**AS-BUILT
EXISTING POND
POWHATAN CROSSING
SECTION IV**

Powhatan Crossing Sec 3/4 Wet Pond
(End of Powhatan Crossing)
BMP ID # PC 025; Approved Plan No. S-15-94

**James City County Environmental Division
Stormwater Management / BMP Inspection Report
Detention and Retention Pond Facilities**

Database Inventory No. (if known): PC 025
 Name of Facility: Powhatan Crossing Section 3/4 BMP No.: _____ of _____ Date: 2/13/01
 Location: POWATHAN CROSSING SEC 3/4 END OF POWATHAN CROSSING
 Name of Owner: 4492 POWATHAN CROSSING
 Inspector: _____
 Type of Facility: WET POND
 Weather Conditions: PARTLY CLOUDY, Low 50's, COLD-DAMP

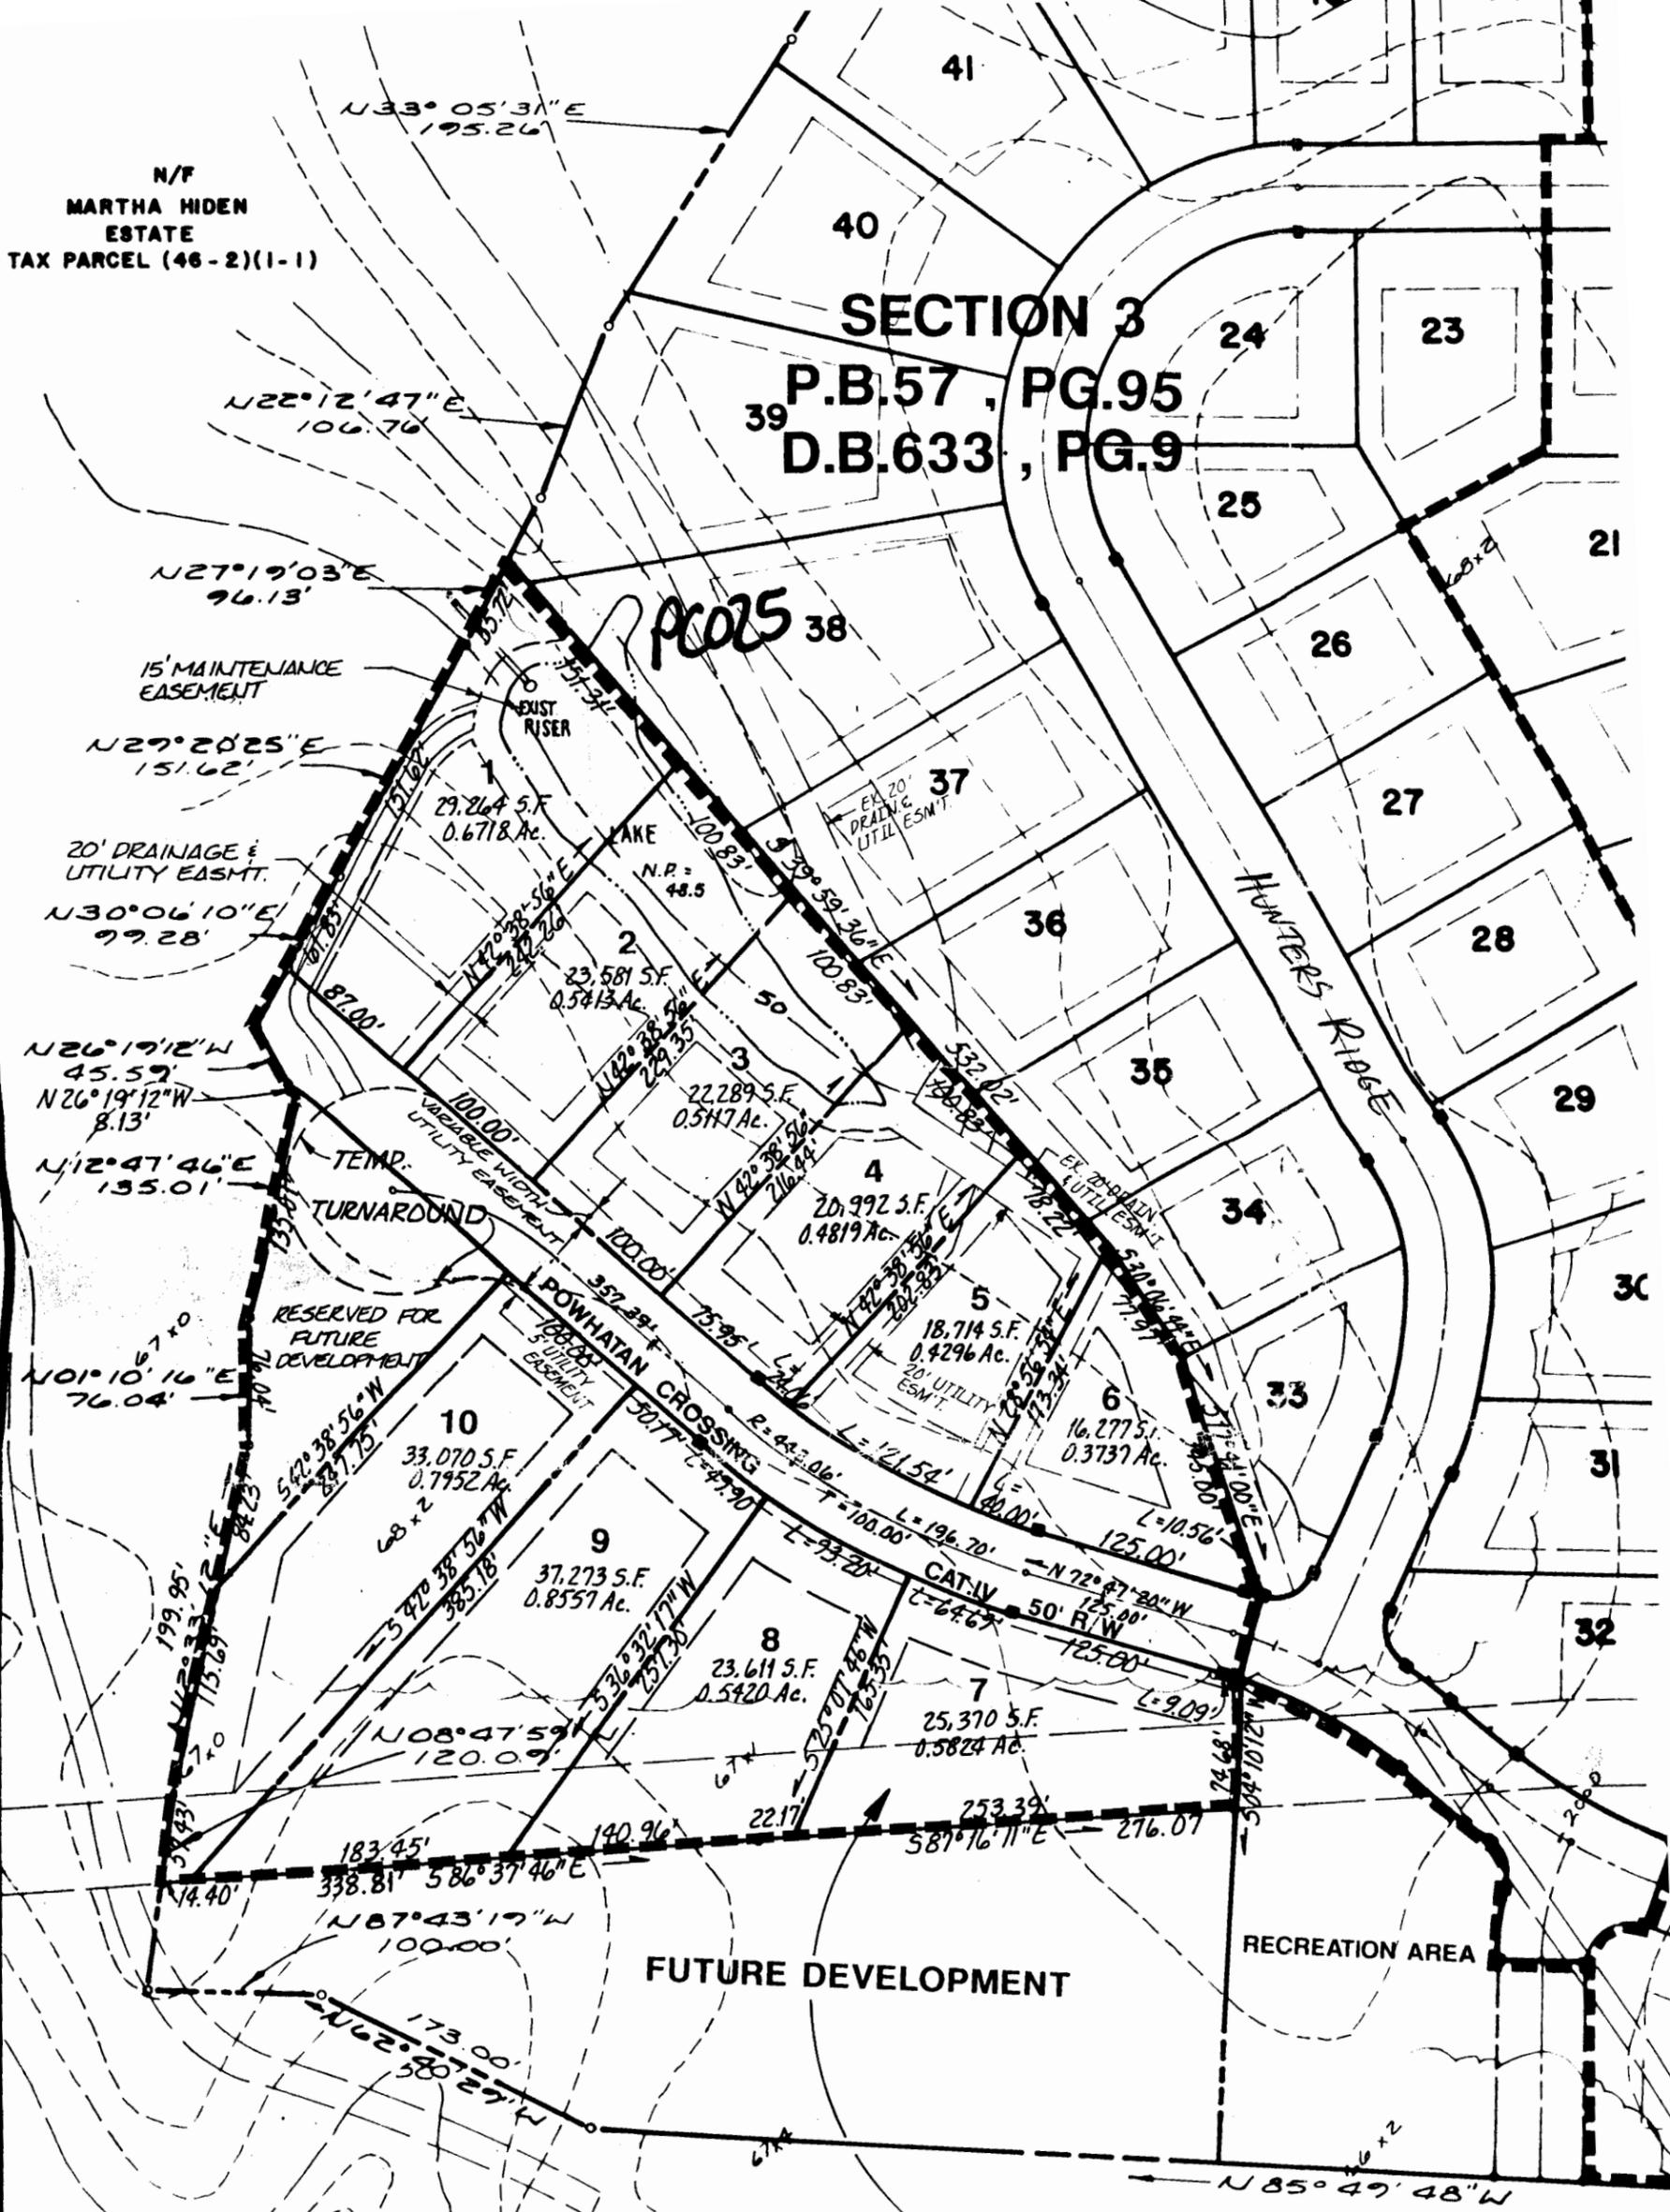
1) A Record Drawing (as-built) was found in the file and appears acceptable. It was prepared by AES, Project No. 6950 dated 3/12/96. No action required.
